Access Compliance Report Public Rights-of-Way (Pedestrian Signals)

Main Street: FAIRHAVEN_AVE Cross Street: ESPLANADE_ST Location: NW

ADA ID: SGRK211007105534 Signal Type: One Push Button-Non APS Overall Compliance: No Severity Scores: BTN 1: 35 BTN 2: N/A No BTN: N/A

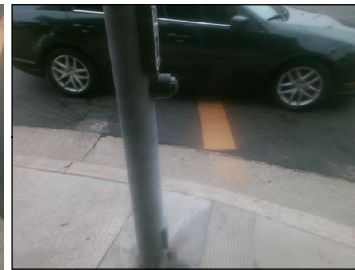
OC Std/PROW: R404.2, MUTCD 4e.08

Possible Solutions: Replace Signal Push Button With APS Button. Remove and Replace Clear Space.
